# PRODUCT CHANGE NOTIFICATION

# #PCN-ICC-JKE9-14

D-ST 2.5 and D-ST 2.5-TWIN change.

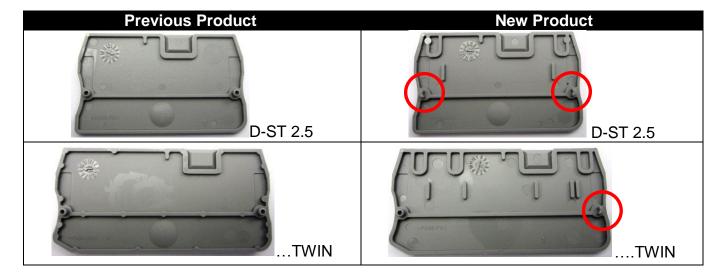
The production process of the PT product range including it's accessories is subject to a continuous improvement process. Therefore, the design of the end cover will be modified for the listed parts.
